Planning and Zoning Commission

July 5, 2022

TO: Planning and Zoning Commission
FROM: Evann Martin, Assistant Planner
DATE: July 5, 2022
RE: Taco Bell – Site Plan

RE: Taco Bell Site Plan

DONOVAN MARINE GRIMES
DIMENSION PLAN

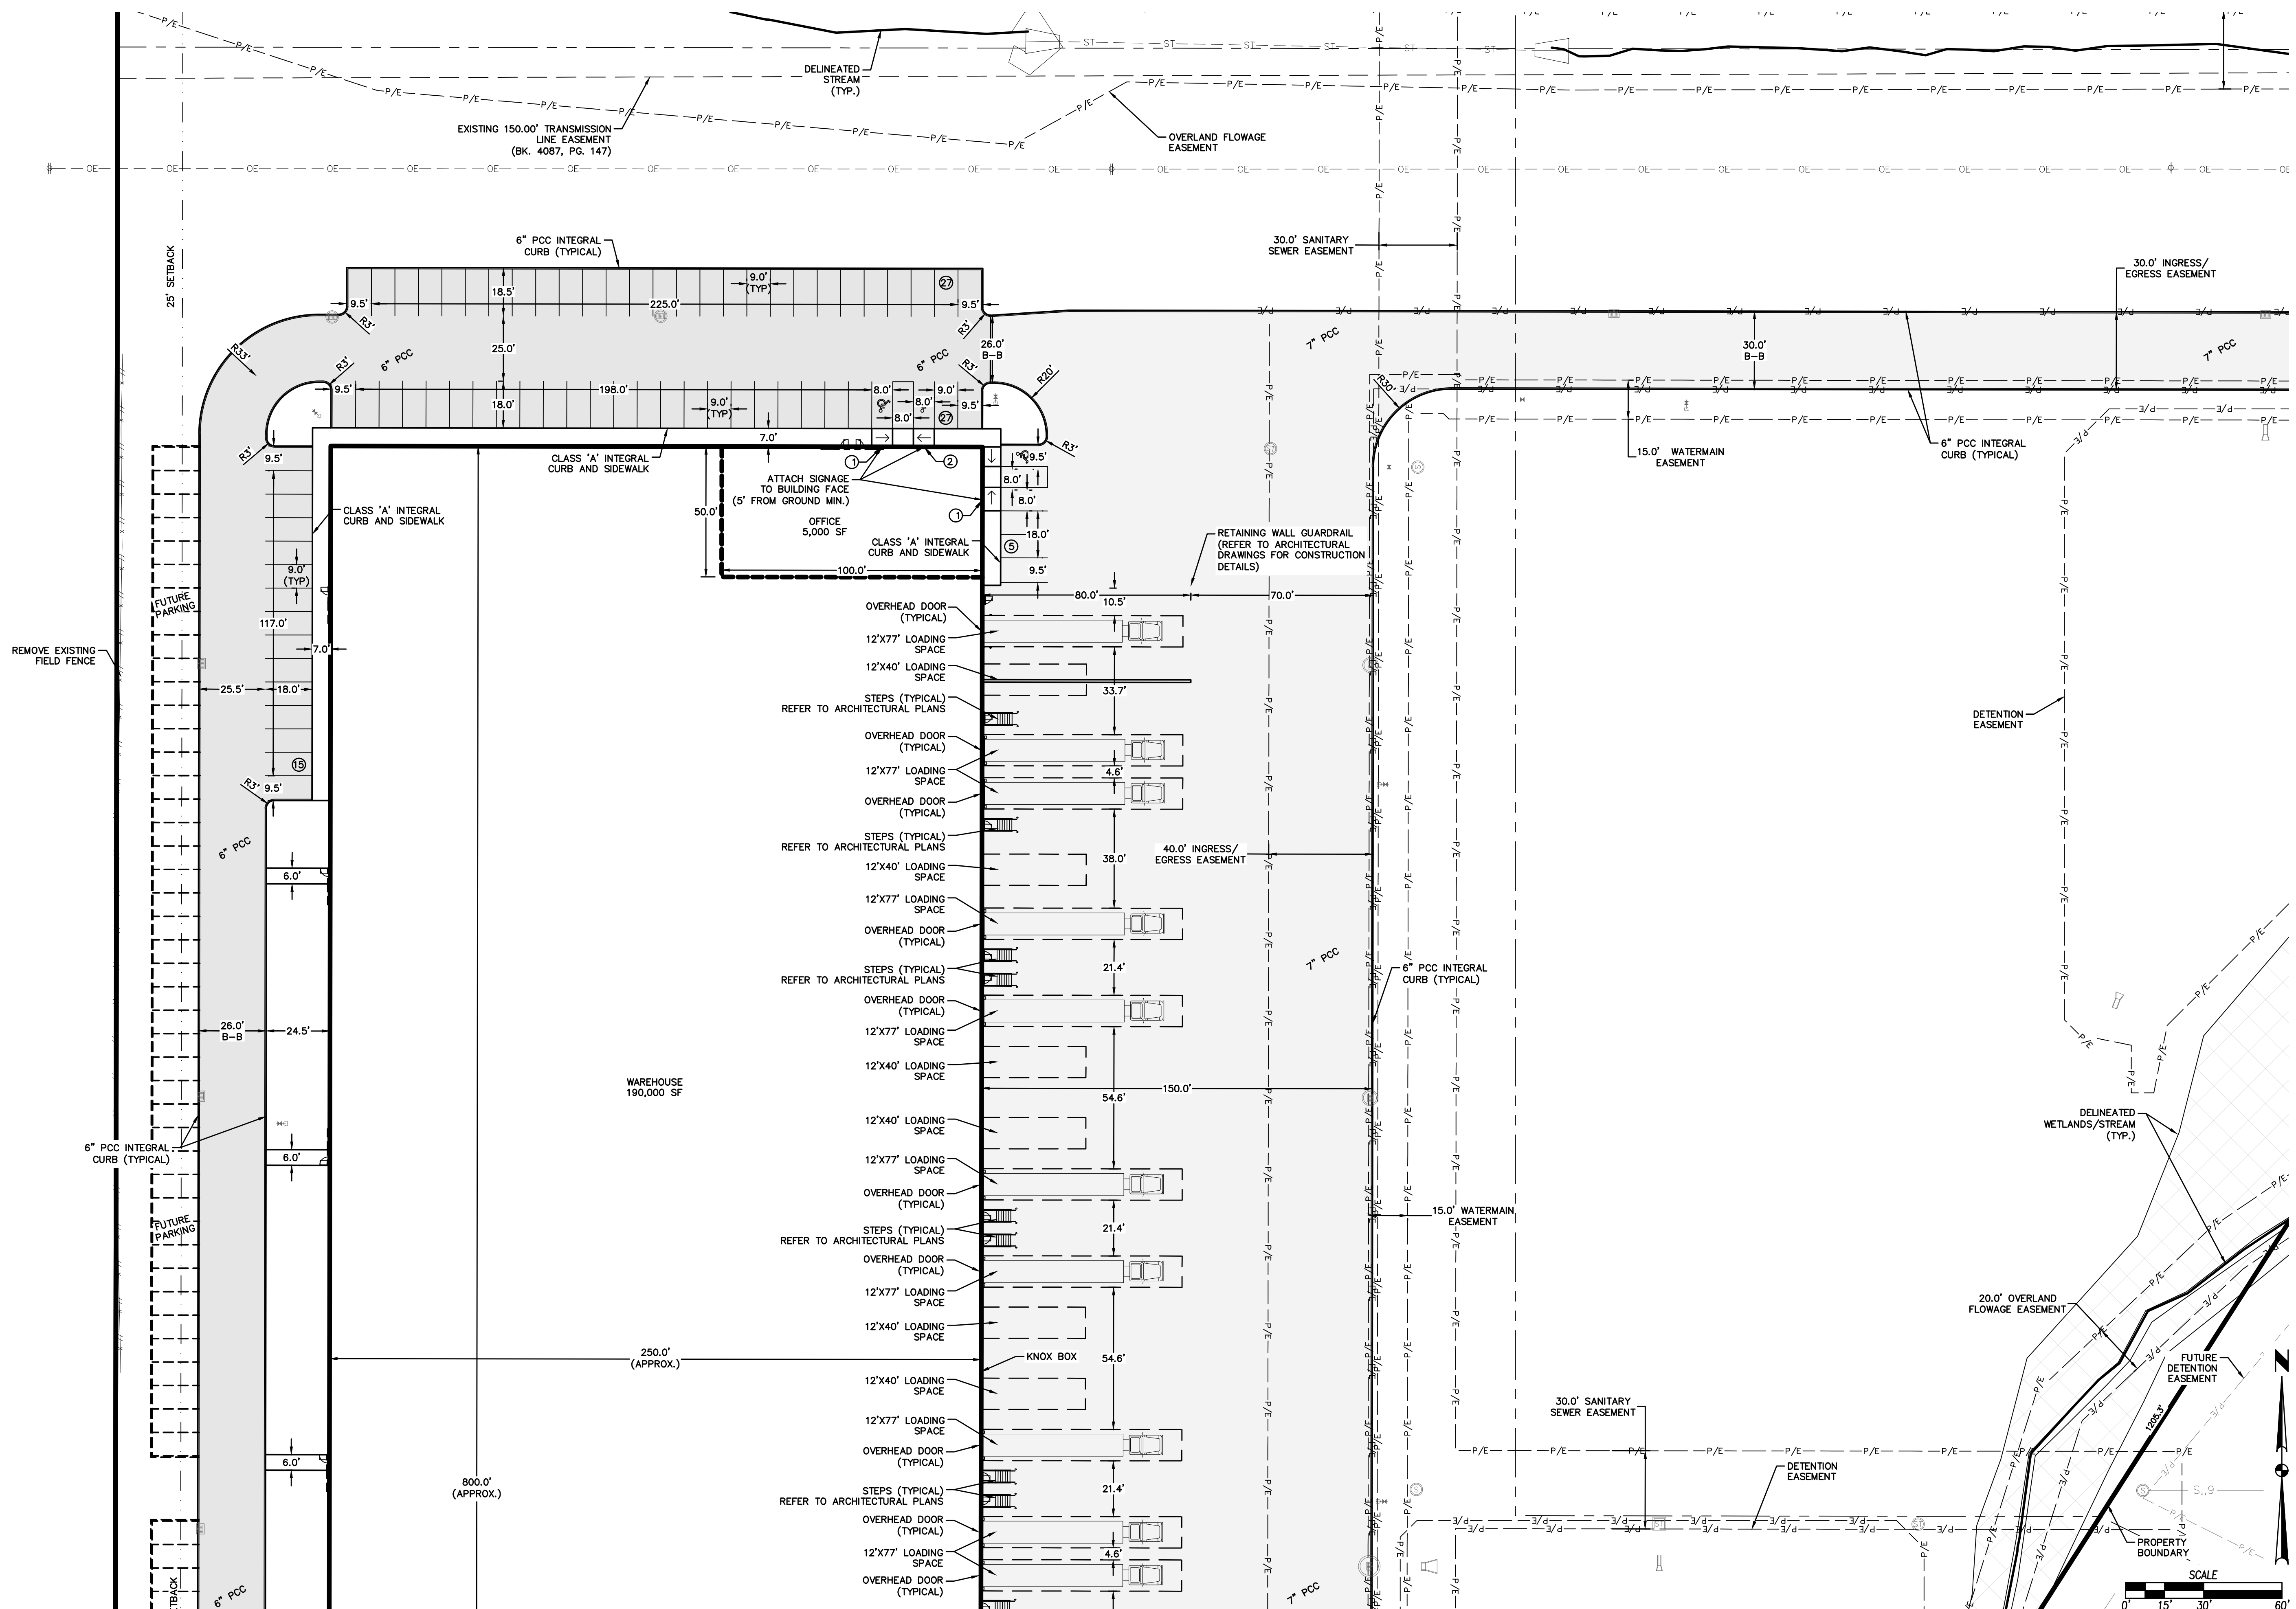
- ~~1. Callout 8" PCC for driveway to ROW.~~
- ~~2. Please show future sidewalk along SW 37th Street. Provide sidewalk through approach/returns.~~
- ~~3. Please shift sidewalk along SW 37th Street into the ROW to avoid the delineated stream. Please also include a callout stating "Future sidewalk to be constructed by the City with SW 37th Street improvements."~~
